Seismic Walkdown Checklist (SWC)

Equipment ID No. QSR42B516 Equip. Class[1] 20

Equipment Description UNIT 1 SERVICE WATER BATTERY FUSE BOX TRAIN A

Location: Bldg. SWIS Floor El. 188 Room, Area 74

F1-116

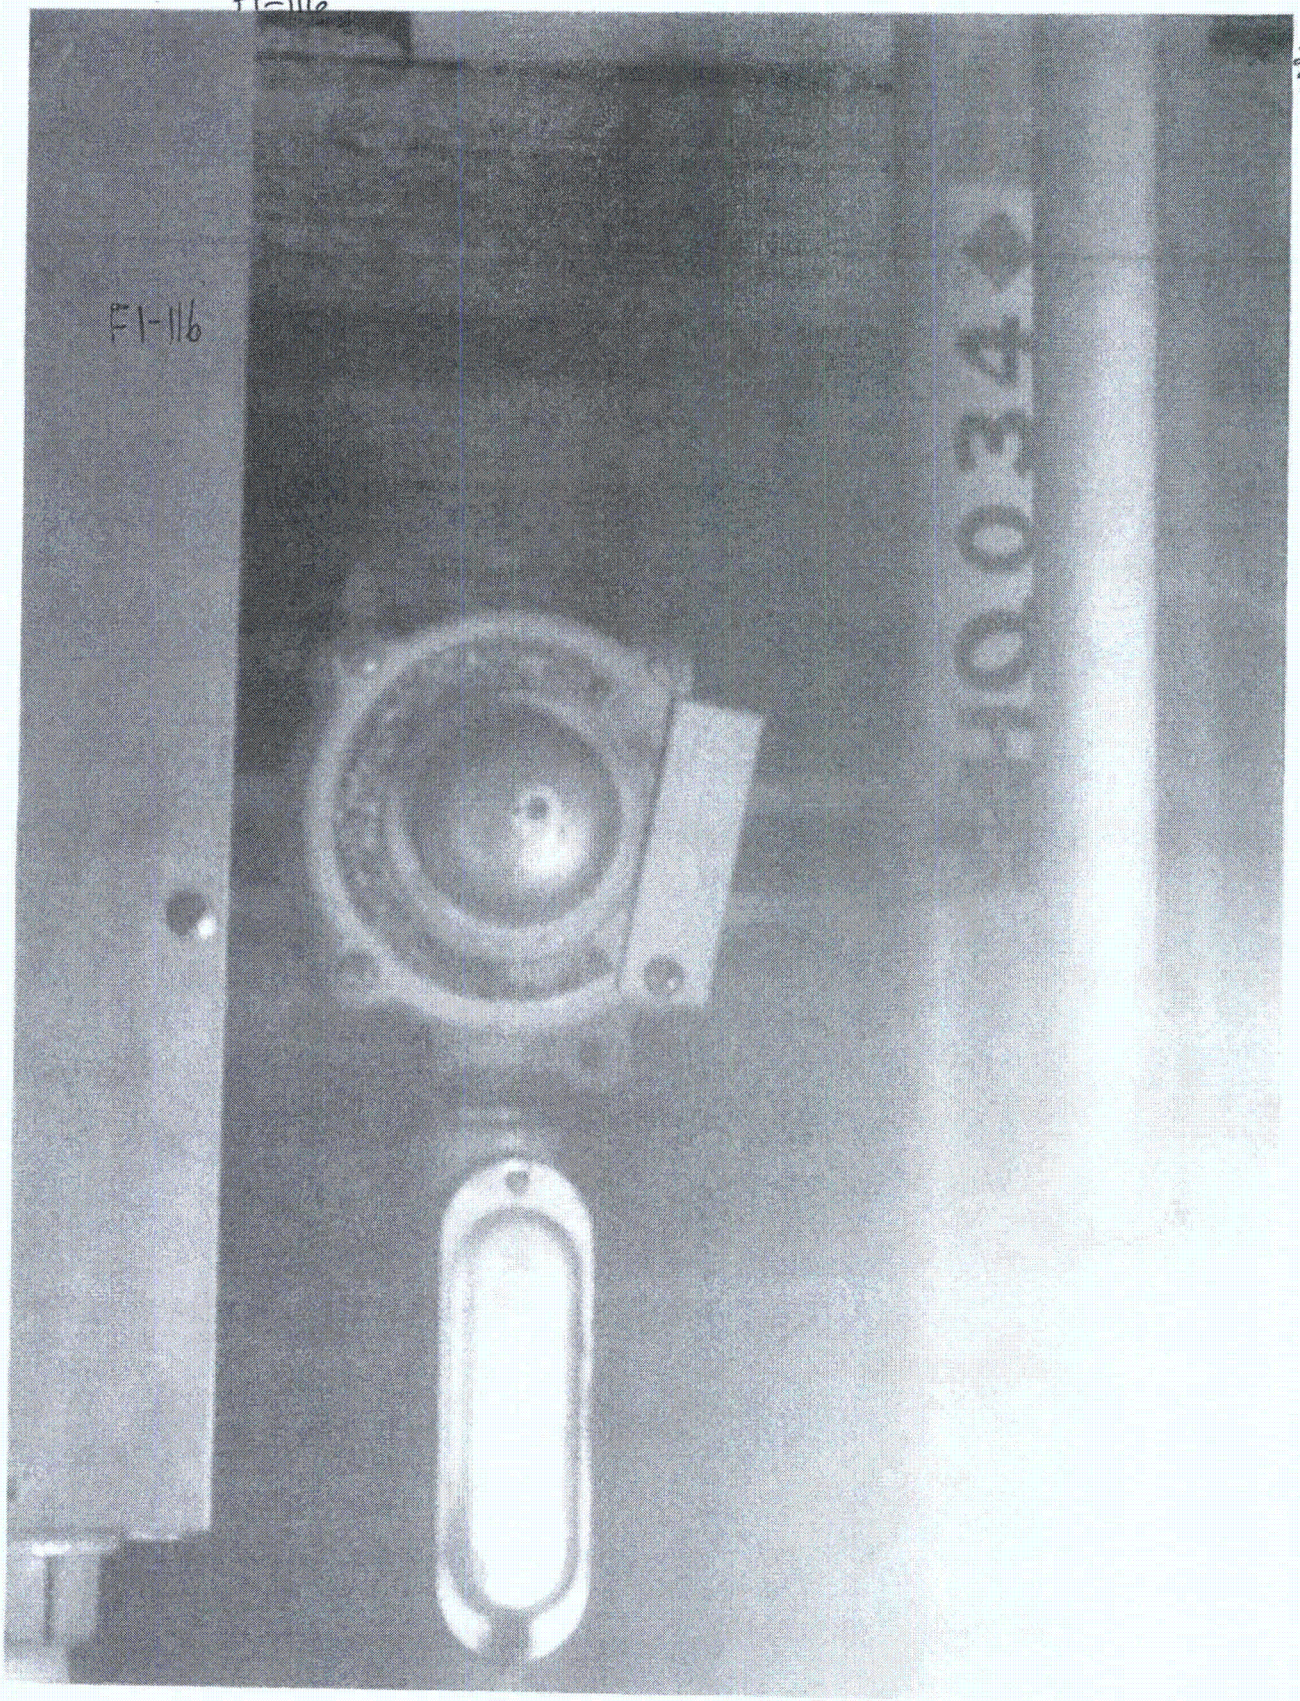
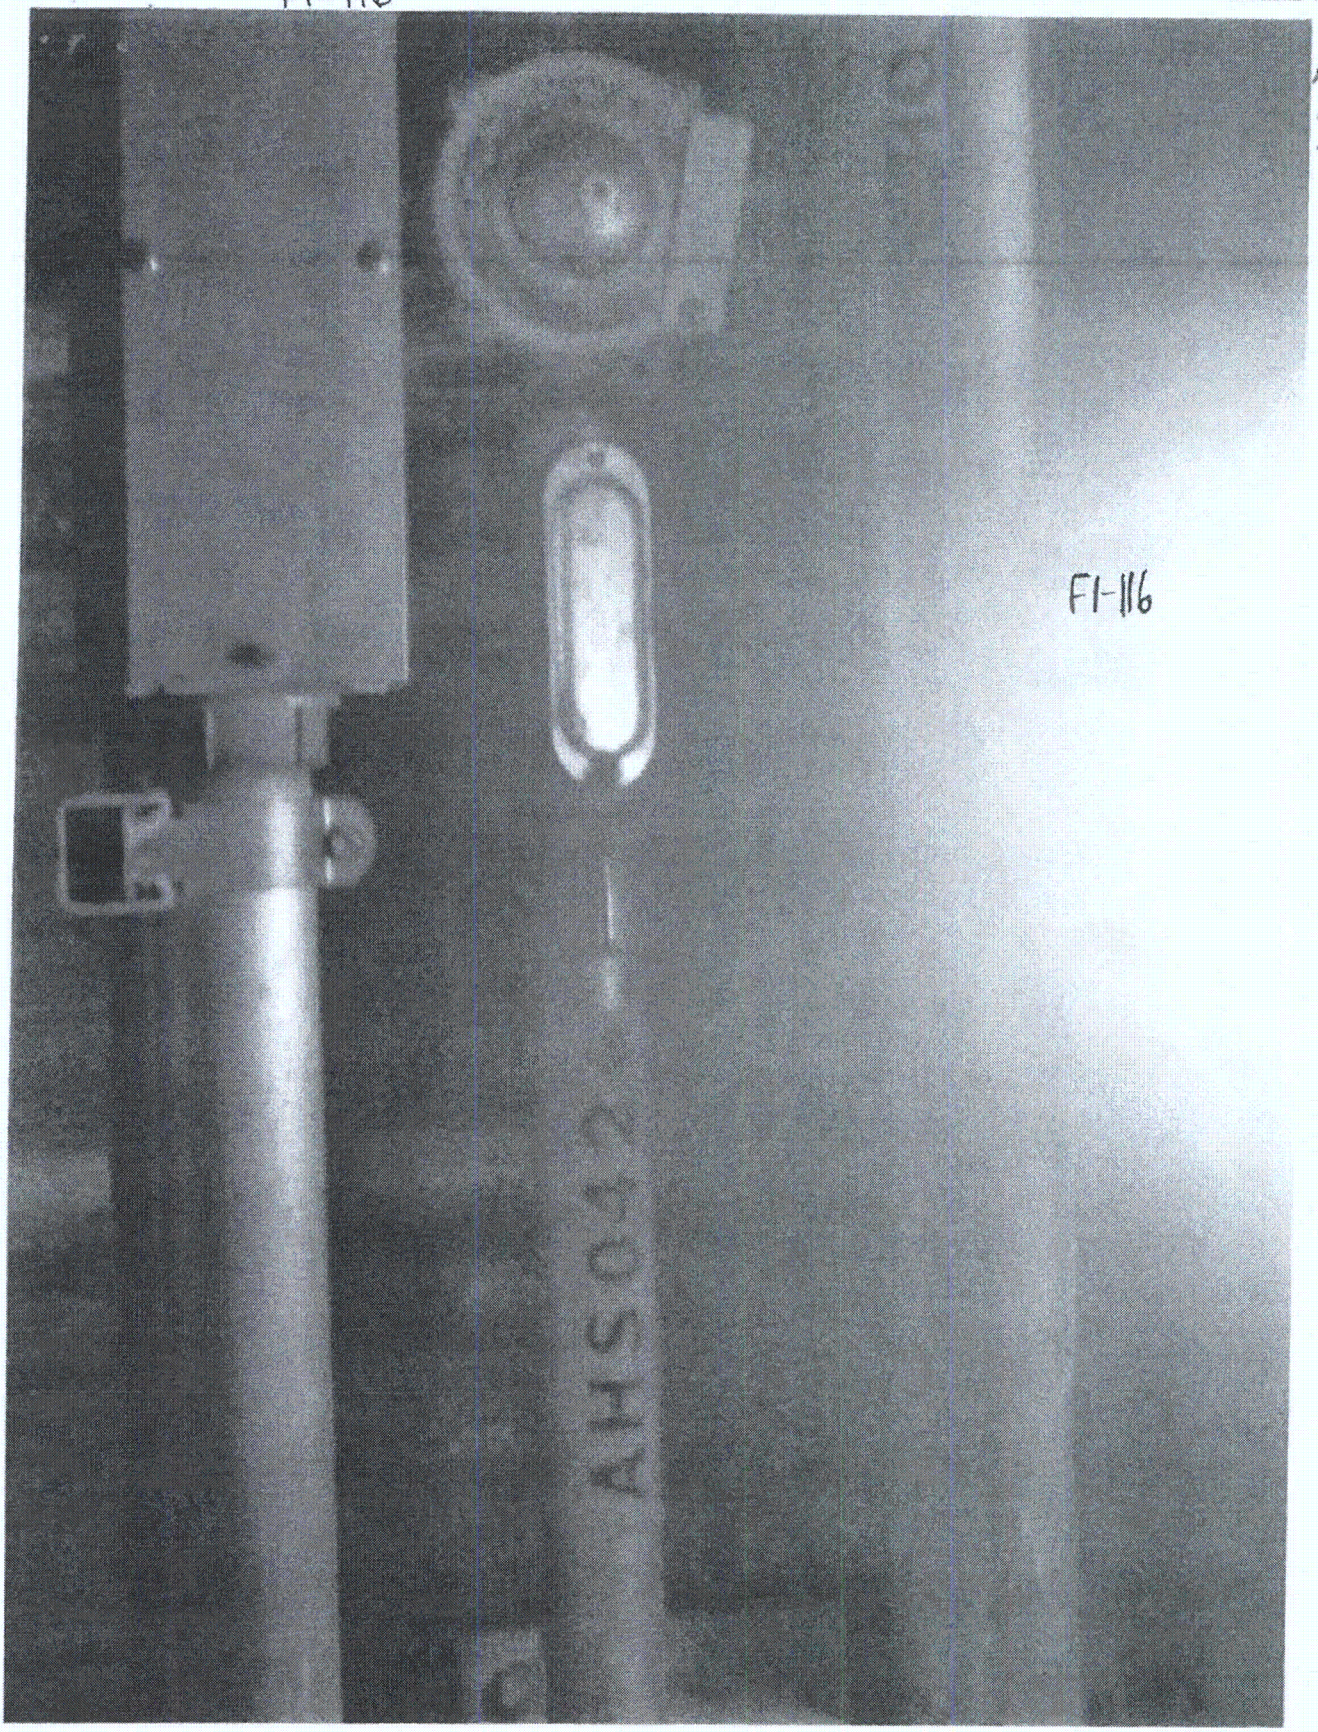
7. Are soft targets free from impact by nearby equipment or structures? Y☒ N☐ U☐ N/A☐
   Tubing too close to piping, see pix, entered in CAP (CR505553, CR504972)

8. Are overhead equipment, distribution systems, ceiling tiles and lighting, and masonry block walls not likely to collapse onto the equipment? Y☒ N☐ U☐ N/A☐
   nothing noted overhead that can collapse, see #7.

10. Based on the above seismic interaction evaluations, is equipment free of potentially adverse seismic interaction effects? Y☒ N☐ U☐
    see #7
